**Design Review Board  
Regularly Scheduled Meeting  
Monday, April 3, 2017  
2:00 – 5:00 PM  
Council Conference Room  
280 Madison Ave N  
Bainbridge Island, WA 98110**

Subject: Duane Cottages HDDP Conceptual Review

PROJECT DESCRIPTION:  
**DUANE LANE  
COTTAGES**

**DUANE LN. COTTAGES-SITE PLAN**  
SCALE: 1'=40'

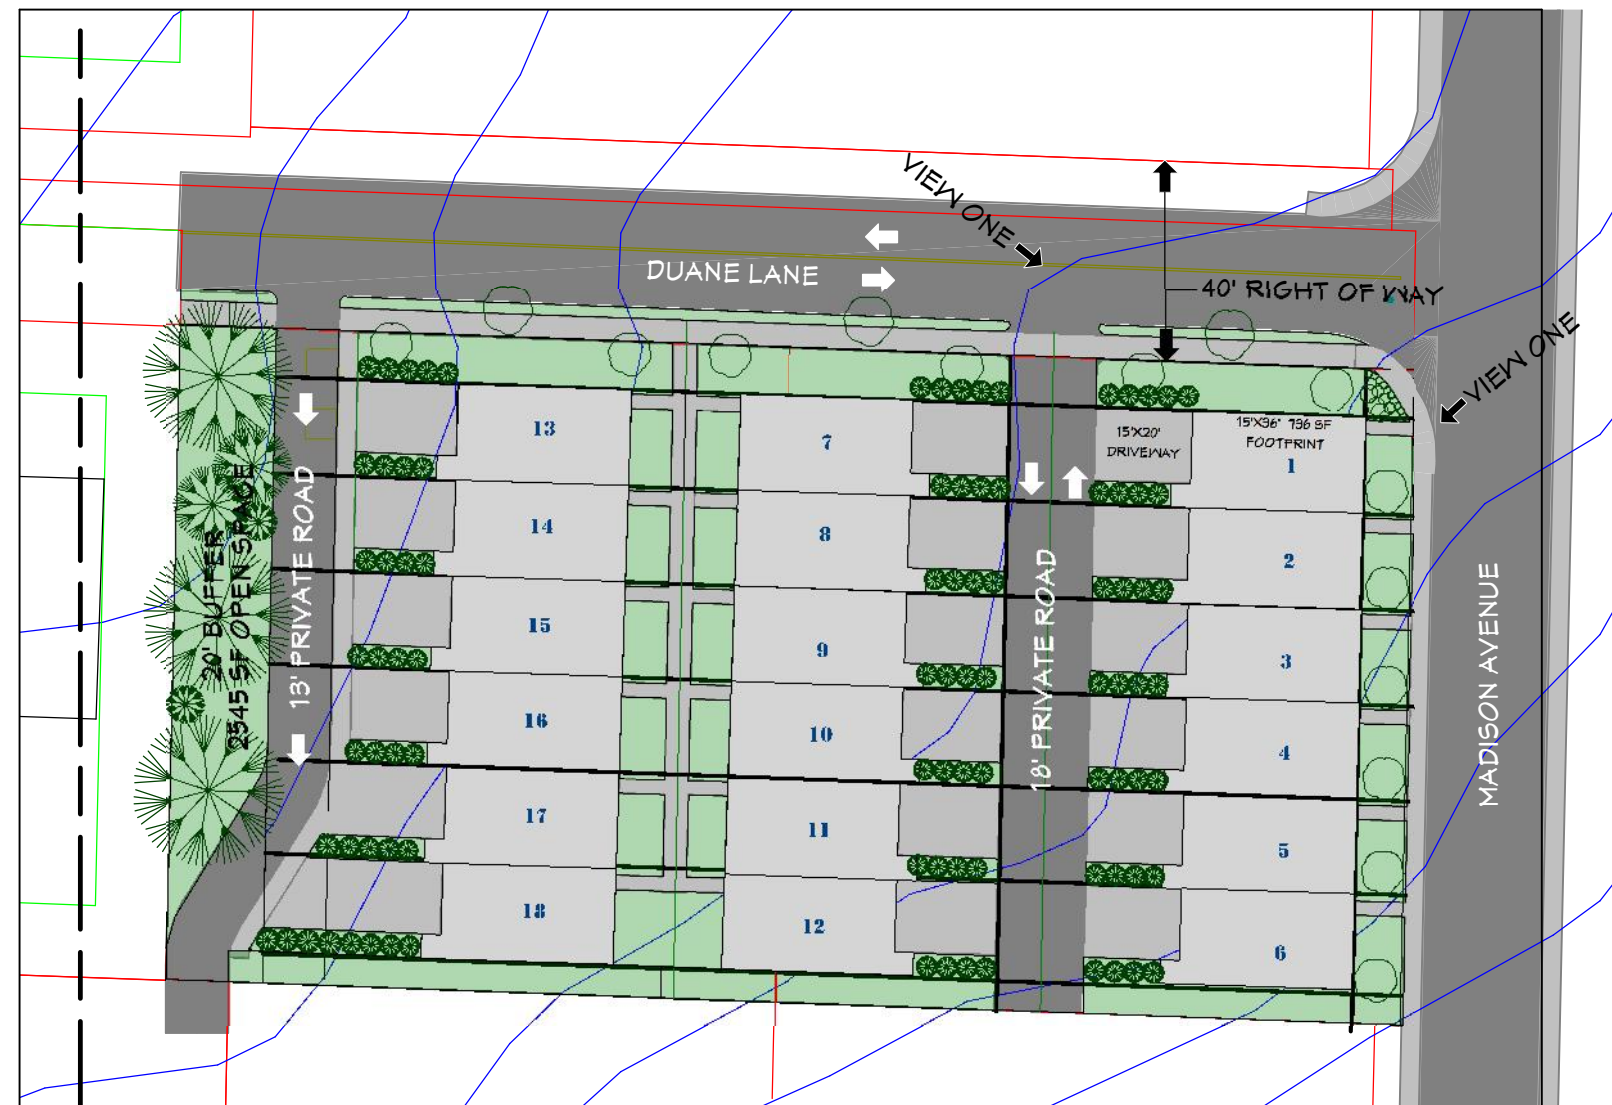
The proposed internal road widths are inadequate to serve the lots. The internal roads must be dedicated public right-of-way, must meet the residential (urban / suburban) standard (DWG 7-050 / 060), and must provide for ingress and egress. Please contact Peter Corelis, Development Engineer, at [pcorelis@bainbridgewa.gov](mailto:pcorelis@bainbridgewa.gov) or 206-3759 to discuss waivers available from road standards.

○ Non-motorized connections: The project should optimally provide connection from Madison Avenue to the Wallace Way trail.

- Floor Area: Maximum residential floor area is .4 (40 percent of lot area prior to right-of-way dedication). Properties may obtain bonus floor area to a maximum of .6 (e.g. by purchasing unused development rights).

- Lot Coverage: 35 percent of the lot area prior to right-of-way dedication ( $\sim 34,848 * .35 = 12,197$ )
- Setbacks: Front (from Madison ROW and Duane ROW) 10 feet; Side 0 feet; Rear 0 feet

- Height: 35 feet
- Landscaping
  - Landscape Buffers:
    - Perimeter buffer: 20-foot width full-screen to west / SFR zoning (BIMC Table 18.15.010-3)
    - Roadside buffer: N/A (BIMC Table 18.15.010-4)
